# METROPOLITAN GOVERNMENT OF NASHVILLE AND DAVIDSON COUNTY

## STAFF RECOMMENDATION 1814 Beechwood Avenue June 19, 2013

**Application:** New construction -outbuildings  
**District:** Belmont-Hillsboro Neighborhood Conservation Zoning Overlay  
**Council District:** 18  
**Map and Parcel Number:** 10416022600  
**Applicant:** Jamie Pfeffer, Architect  
**Project Lead:** Sean Alexander, sean.alexander@nashville.gov

1 SITE PLAN  
SCALE 1/32" = 1'-0"

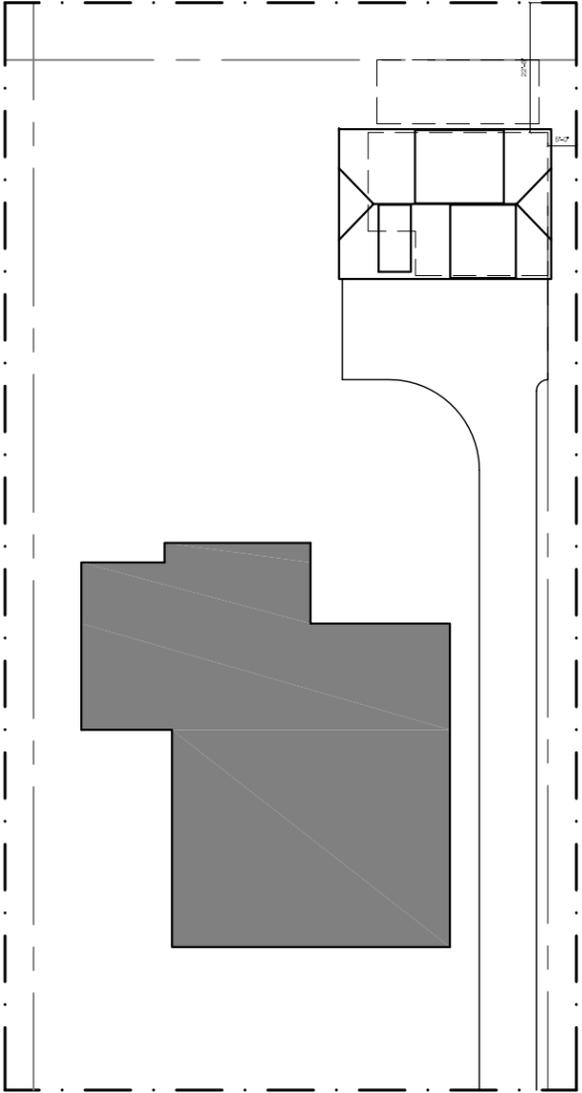
The garage will be located behind the house, five feet (5') in from the side property line and twenty-three feet (23') from the rear. This will be consistent with the placement of historic accessory buildings and meets the required minimum setbacks. The rear pergola, with a six foot (6') side setback and a ten foot (10') rear setback, will also be compatible with the context and meet the bulk zoning requirements. The new structures will meet guideline II.B.1.c.

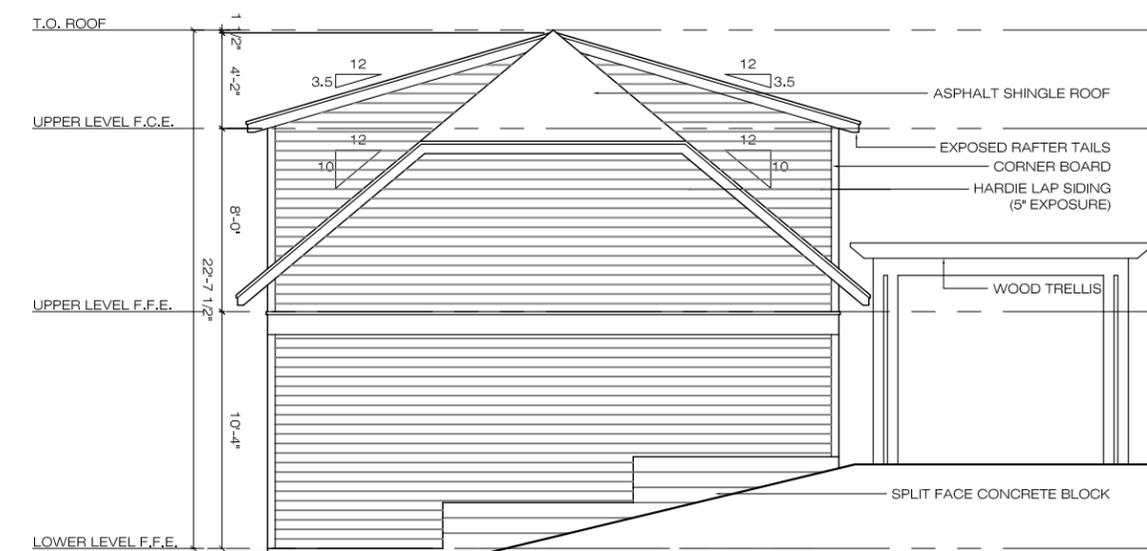
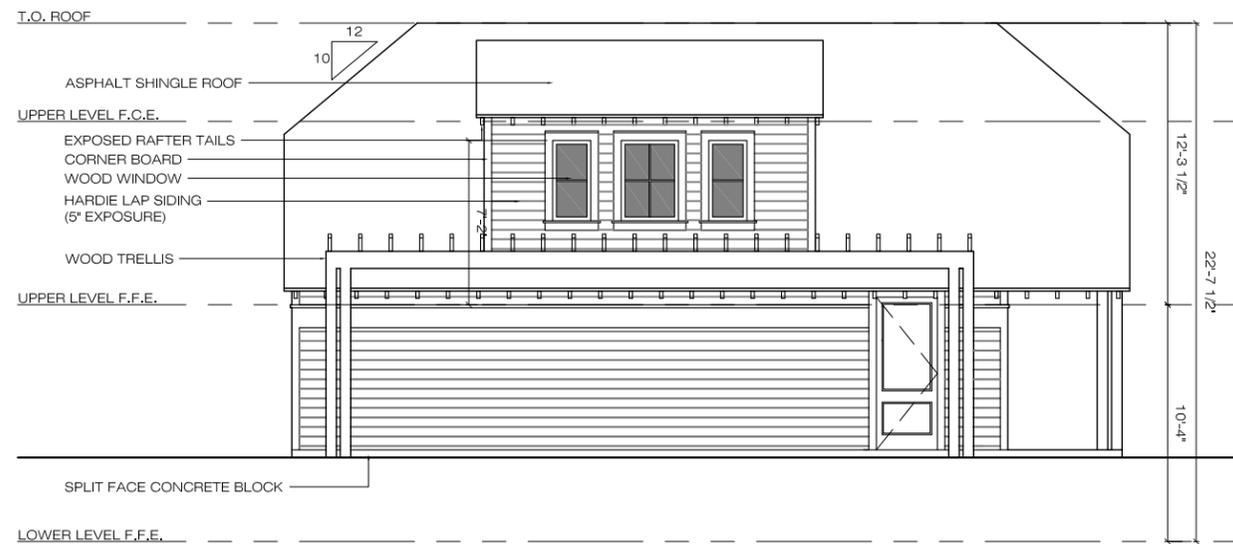
The roof of the building will be a clipped gable with a side-oriented ridge, matching the roof form of the house. The ridge height will be twenty-three feet (23') above grade, with an eave height of eleven feet (11'). This is approximately equal to the heights of the house, but because the grade rises toward the alley, the eave and ridge heights of the garage will be lower at the rear by five feet (5'). These heights are compatible with those of surrounding historic buildings and meet guideline II.B.1.a.

The primary roof of the accessory building will be a clipped gable with a side-oriented ridge, similar to the roof of the house. It will have shed-roof dormers on the front and rear slope. The pergola will have a flat, open-raftered roof. These roof forms are compatible with the house and surrounding buildings and meet guideline II.B.1.e.

The new garage will be clad with smooth cement-fiber siding with a five inch (5") exposure. The roof will be composite shingles matching the color and profile of the roof of the house, and the foundation will be split-faced concrete block and poured concrete. The windows, doors, porch columns and trim will be wood. The pergola will be constructed of wood. These materials meet guideline II.B.1.d.
